City of Wichita Standard for

Residential Wood Framed Decks

Amendments and Changes to the AWC DCA6-09 Document

Revised 12/22/2011

PAGE 8 OF AWC DCA6-09 [See attachment 4 for optional use of 4 x 4 posts]

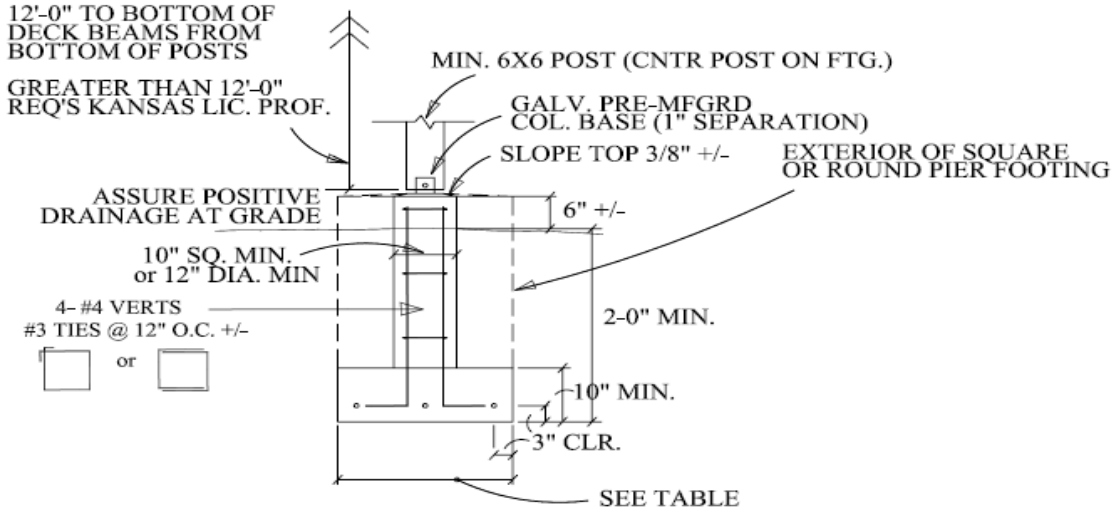
- a. Amend Figure 8 to include the wording: “Notches in posts MUST NOT be overcut.”
- b. Amend Figure 8 to include the wording: “Counter bores are allowed only in the beam; not in the post.”

Page 15 OF AWC DCA6-09

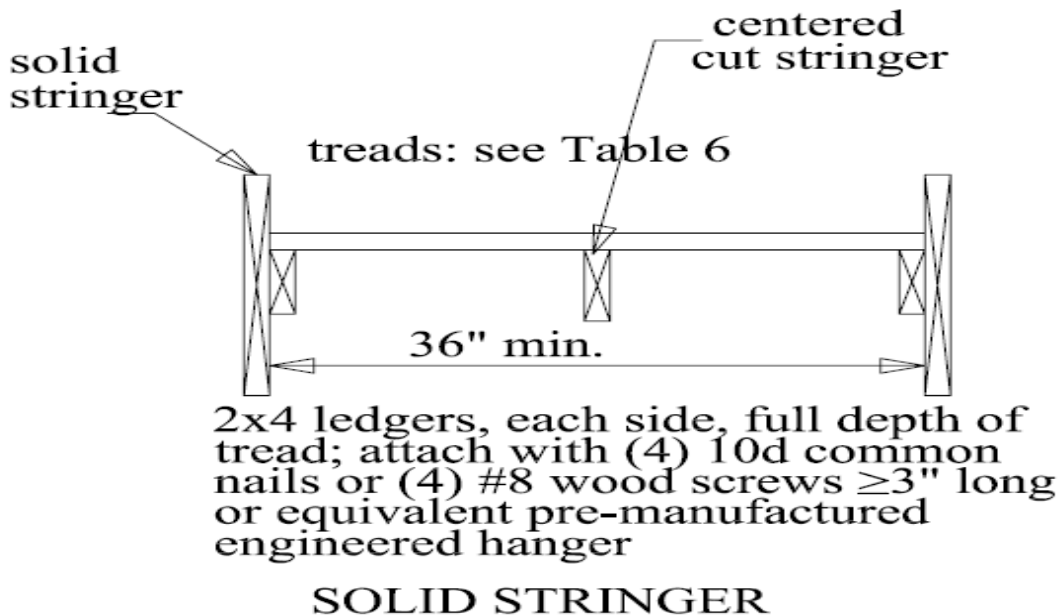
- a. Under “**Diagonal Bracing:**” Omit the following: “Decks attached to the house as shown in Figure 23A do not require diagonal bracing perpendicular to the house.”
- b.
- c. Under “**Deck Supported by Ledger - Attachment to House:**”
 - i. Omit the reference to Figure “16”
 - ii. Omit reference to IRC Code section [R502.2.2] and replace with [R502.2.1]
 - iii. Omit the following: “The lateral load connection required shall be permitted to be in accordance with Figure 23A. Hold down tension devices shall be provided in not less than two locations per deck, and each device shall have an allowable stress design capacity of not less than 1,500 lb [R502.2.2.3]. See the *Commentary* to this document for additional information on applicability of this provision.”
- d. Omit Figure 23A.
- e. Amend Figure 24 as follows: “openings shall not allow the passage of a 4” 4½” diameter sphere”
